28F016SA/DD28F032SA SPECIFICATION UPDATE

Release Date: July 1996

Order Number: 297408-006

The 28F016SA/DD28F032SA may contain design defects or errors known as errata. Characterized errata that may cause the 28F016SA/DD28F032SAs' behavior to deviate from published specifications are documented in this specification update.

Example System Software Flowchart That Will Not Encounter “Completion with Command Error or Invalid Device Operation” Condition

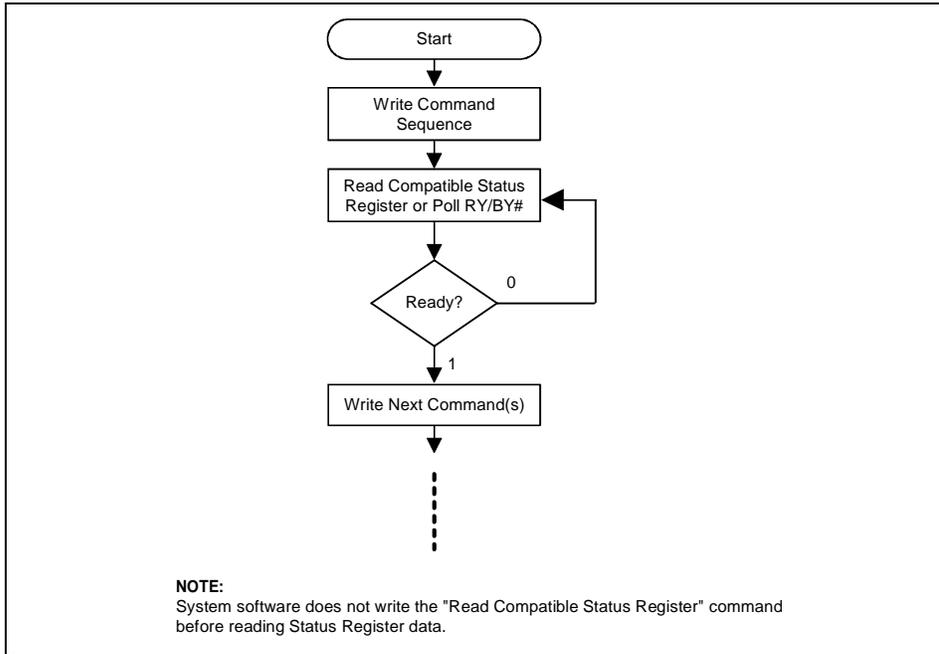
PROBLEM: Systems in which software, after initiating device automation via a queueable command sequence, writes another command(s) to the device before automation completes may initiate unintended device operations.

Option 1: Polling for “Ready” Indication

Systems that poll the RY/BY# pin or WSMS bit (CSR.7) for “Ready” indication before writing another command to the device will not encounter this errata. This is illustrated in the *Example System Software Flowchart, etc.* figure below, and in flowcharts 11-1 and 11-2 (without erase suspend) of the *16-Mbit Flash Product Family User’s Manual*.

Timing Waveform Showing Specification Ranges That Will Not Cause the “Completion with Command Error or Invalid Device Operation” Condition

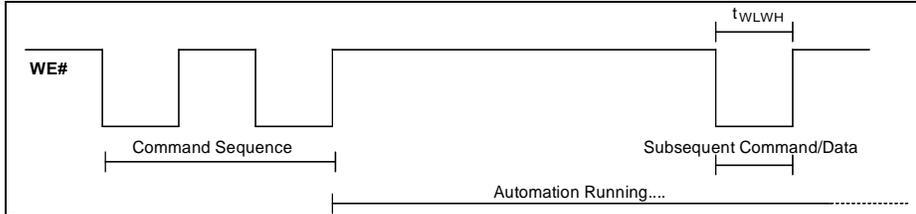
Option 2: WE# and CE# Pulse Width Restrictions

For WE#-Controlled Write Operations, a WE# pulse width defined by the ranges of parameter t_{WLWH} in the table below, will result in a system that does not exhibit this errata. (Note: timings are also bounded by specifications in the device datasheet). When performing CE#-Controlled Write Operations, this restriction equally applies to the CE# pulse width (t_{ELEH}).

V _{CC} Supply Voltage	t_{WLWH}	t_{ELEH}
5V	<75 ns	<75 ns
3.3V	<100 ns	<100 ns

Erase Suspend to Read Array with Compatible Status Register

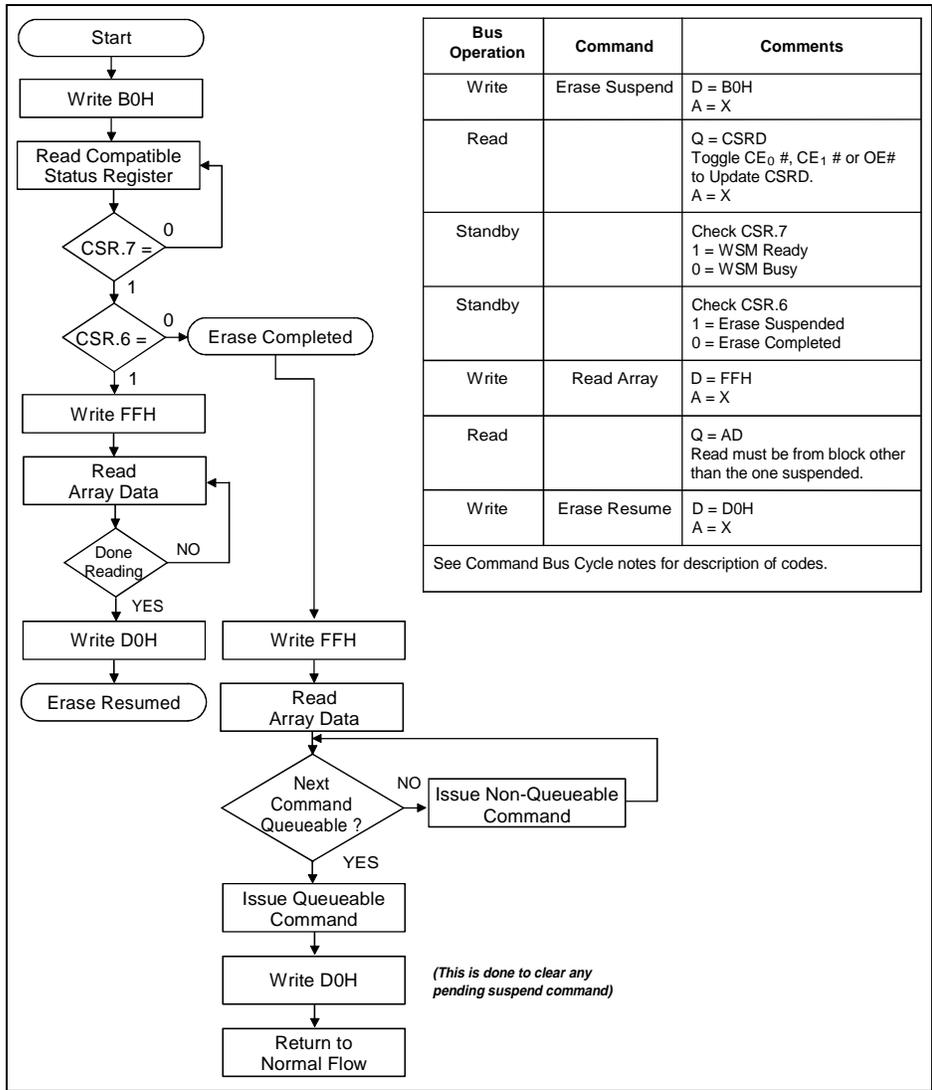
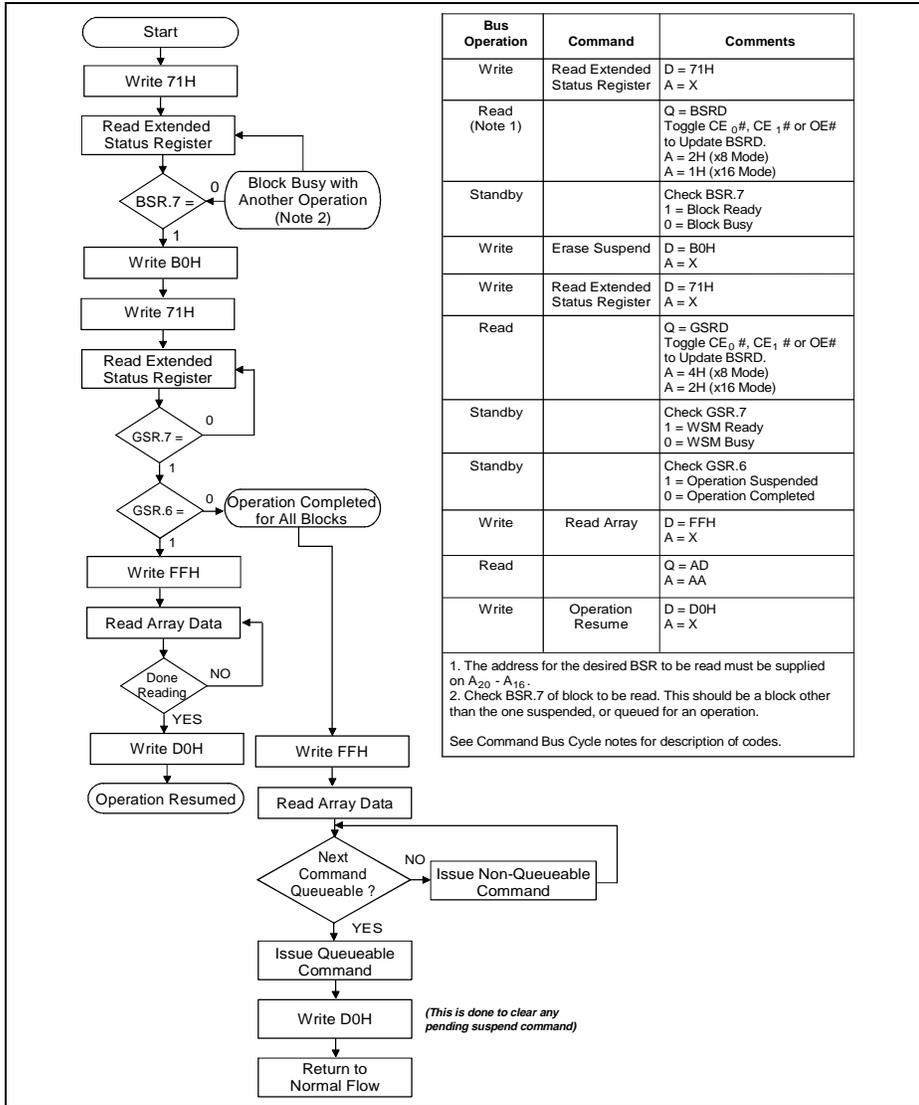
PROBLEM: If an Erase Suspend command is issued after completion of the Erase Cycle (either Single Block Erase or Erase All Unlocked Blocks) or too late in the Erase cycle, such that the Erase completes before the Status Register Suspend bit is set, the device will queue this unserviced Suspend request.

- A. If another Erase command is issued at some time later, the device then assumes that the pending Suspend request is still valid and will automatically Suspend the current Erase.
- B. If any queueable command is in the command queue waiting for execution while another queueable command is in progress, the Write State Machine will suspend its operation after completing the current command. (Refer to the *16-Mbit Flash Product Family User's Manual*, Section 11-1 for the queueable command list.)

WORKAROUND: Intel developed a software workaround to this errata, by inserting a second Resume command (DOH) following any queueable command in the Erase Suspend flowcharts. Both Erase Suspend to Read Array flowcharts (*16-Mbit Flash Product Family User's Manual*, Figures 11-3 and 11-12) detailing this workaround are attached to this errata (see the *Erase Suspend to Read Array with Compatible Status Register* and *Erase Suspend to Read Array with Extended Status Register* figures, which follow). This erratum results in the *Erase Suspend with Compatible Status Register* flowchart being incompatible with the 28F008SA *Erase Suspend* flowchart.
